19 August 2019

Pearl High School Multipurpose Building

## ADDENDUM NO. 01

**1** POWER PLAN  
E-200 Scale: 1/8" = 1'-0"

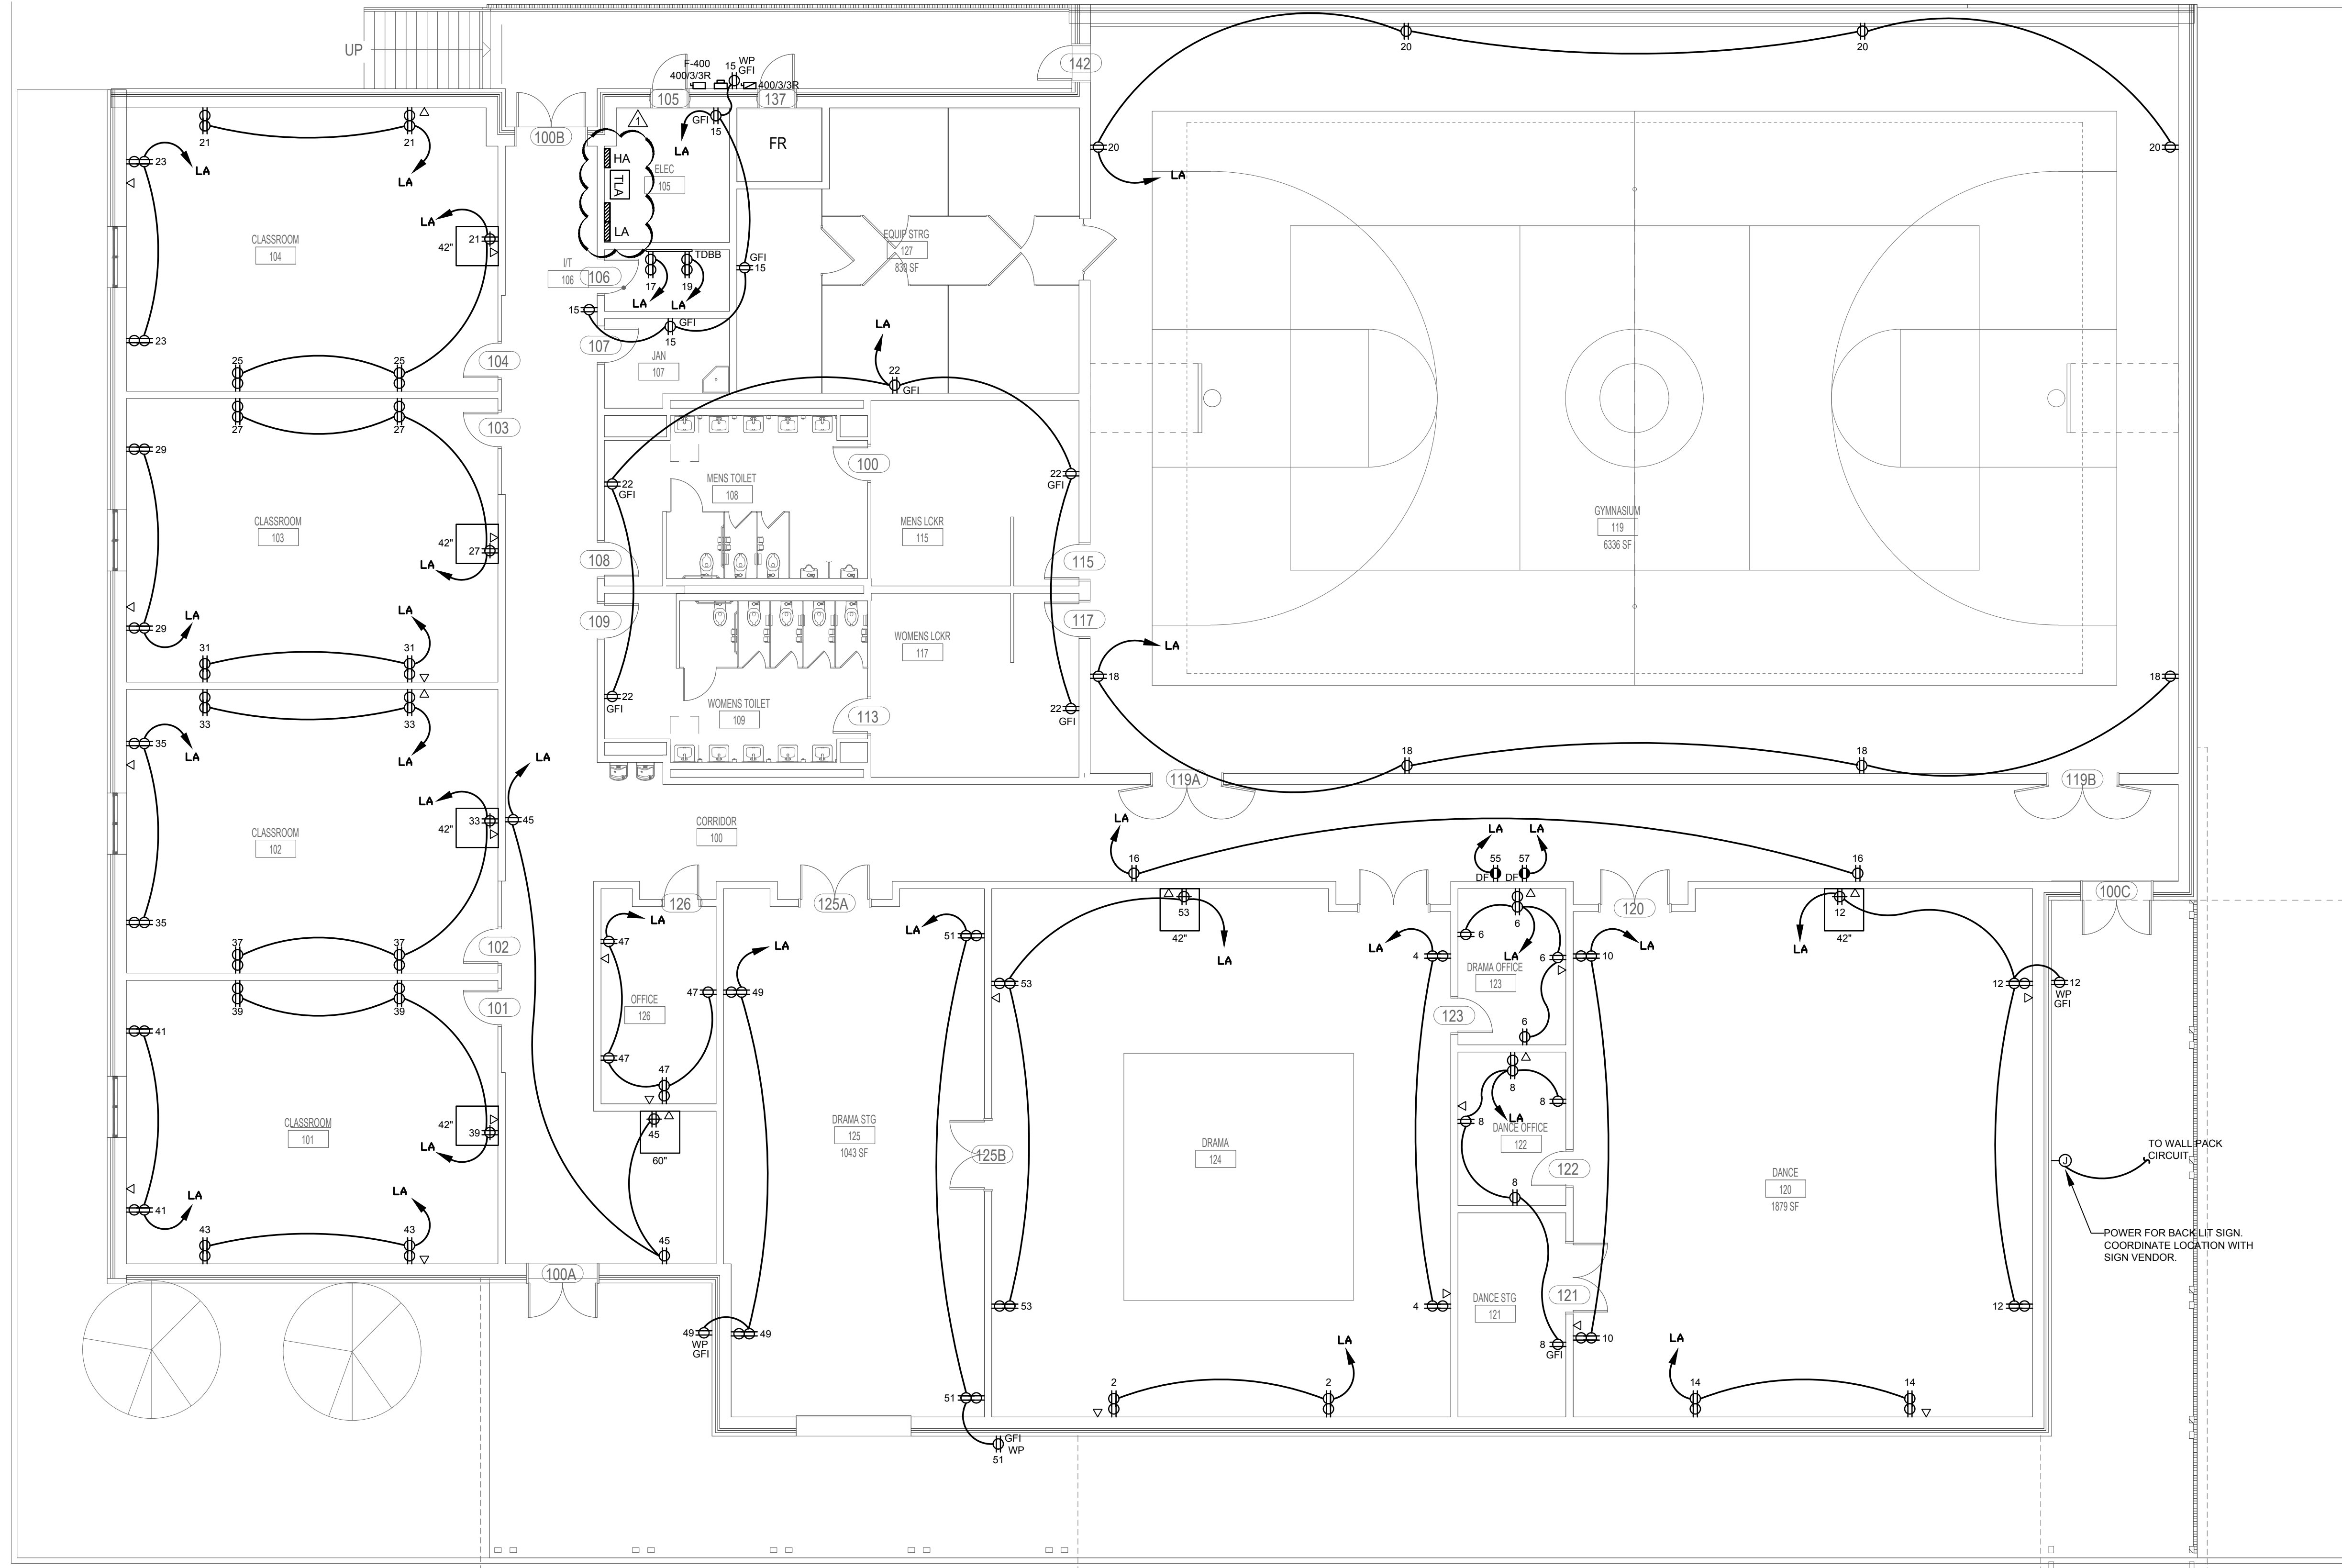
**REPLACE** sheet with attached revised sheet **E-200**.  
**Revises** location of electrical panels in Elec 105.
